Applicant: Chad Millner; City of Edina
Consultant: Jeff Weiss; Barr Engineering
Project: Stream Channel Stabilization
Location: Braemar Branch; Valley View Road and Hilary Lane: Edina
Rule(s): 5 and 7
Reviewer: BCO

Permit #: 2019-95
Project Name: Stream Stabilization – Braemar Branch; Valley View Road and Hilary Lane: Edina
Approval Date: August 21, 2019

CITY OF EDINA		BANK SLOPE REPAIR STABILIZATION AND SANITARY SEWER PROTECTION	
 7450 METRO BOULEVARD EDINA, MN 55439-3037 Ph: 952-826-0371 Fax: 952-826-0392		REMARKS REVISIONS NO DATE BY NO DATE 10/19-95	
HEREBY CERTIFY THAT THIS PLAN WAS PREPARED BY ME OR UNDER MY DIRECT SUPERVISION AND THAT I AM A DULY LICENSED PROFESSIONAL ENGINEER UNDER THE LAWS OF THE STATE OF MINNESOTA DATE: 08/08/19 LIC. NO. 43970 DRAWN: CAM CHECKED: CAM APPROVED: CAM DATE: 08/08/19 CONTR. # 19-20NB SHEET 1 of 1

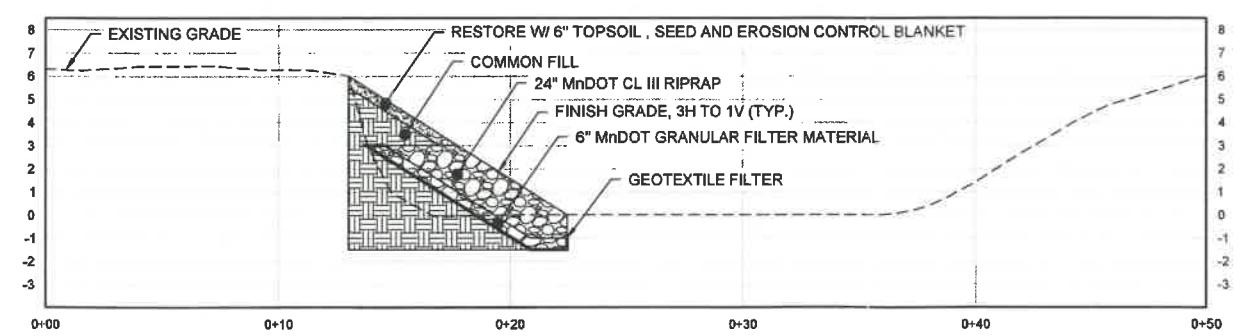
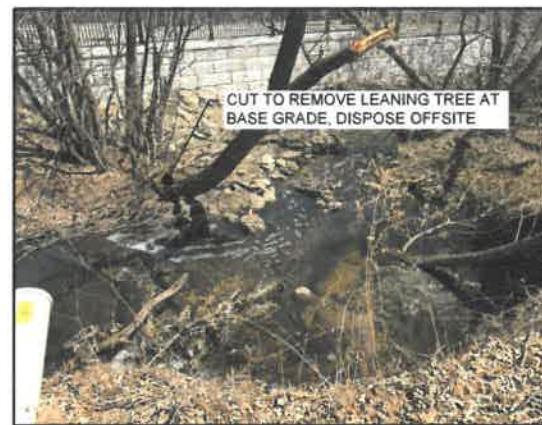
The project proposes the use of Class III field stone rip-rap, MnDot 2511 and 3601, having a maximum size of 24-inches, with 8-inches of granular filter material, MnDot 3601. The objective is to maintain the natural characteristics of the creek system yet provide for a stable slope that forms the creek bank.

Filter material used will be 6-inches in depth complying with MnDot 3601. A geotextile filter fabric will be installed between the native soil and the granular rip-rap. The rip-rap will be 1.33 times the maximum stone diameter. Toe boulders will not be used.

The Atlas 14 100-year high water elevation at this location is 848 M.S.L., approximately the top of the bank. The top of the bank in this area is approximately 6 feet above the thalweg of the creek. The rip-rap will extend three feet up the bank to provide the necessary toe protection with the native restoration to the top of the bank.

The plans show the stabilized channel banks at a slope of 3:1.
